IN THE MATTER OF Proposed Plan Change 14 Housing and
Business Choice pursuant to Part 5, subpart
5A and Part 6 of Schedule 1 of the Resource
Management Act 1991

MINUTE 55: RESPONSE TO COUNCIL REGARDING FINAL CLARIFICATIONS SOUGHT

APPENDIX 1 – Based on Council Memorandum, 20 September 2024, Appendix 2 – MAPPING CHANGES

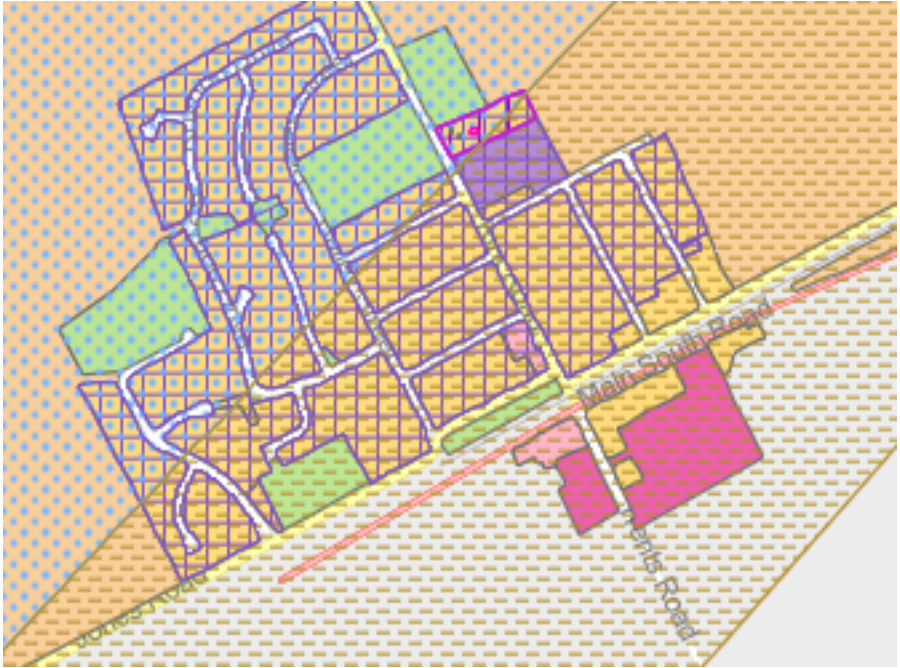
#	Area / Feature	Change required	Source / consequential change	IHP Response/Comment
		<p style="text-align: center;">Council Reply</p> 		
3.	159 Main Road	<ol style="list-style-type: none"> 1. Re-zone 159 Main Road from LCZ to Industrial General Zone. 2. Sites either side shown MRZ sites should also be zoned Industrial General Zone – to the same extent as the operative zone (i.e retain operative IG zone). 3. The Industrial Interface QM should be removed from any non-residential zone accordingly. 	Response to Minute 53	The Panel notes that the zoning is correctly shown on the webmap.

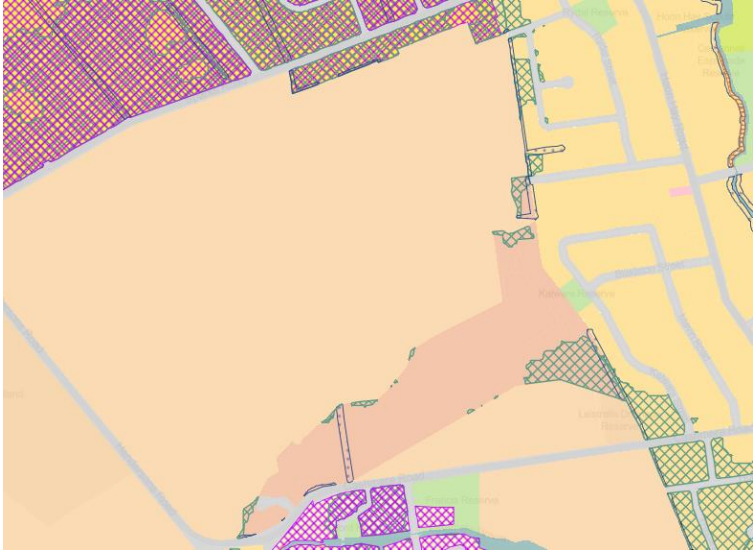
4.	180 and 178 Riccarton Road	<p>180 and 178 Riccarton Road should be re-zoned as HRZ.</p> 	Further consequential change	The Panel notes that the zoning is correctly shown on the webmap.
5.	Slope Instability QM – Sumner	The residential portions of the properties at 21 and 25 Finnsarby Place in Sumner should be zoned Residential Hills not MRZ given that they are fully within the Rockfall Management Area 1.	Further consequential change	The Panel notes that the zoning is correctly shown on the webmap.

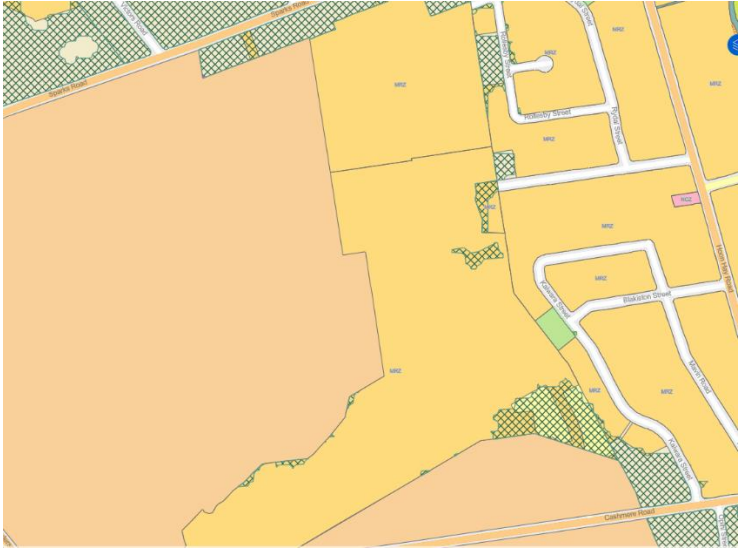
6.	Industrial Interface QM – Sydenham	Apply the 40m Industrial Interface QM buffer to the residential areas adjoining the Sydenham Industrial General Zone (given the recommendation to retain this zoning).	Further consequential change	The Panel notes that the zoning is correctly shown on the webmap.
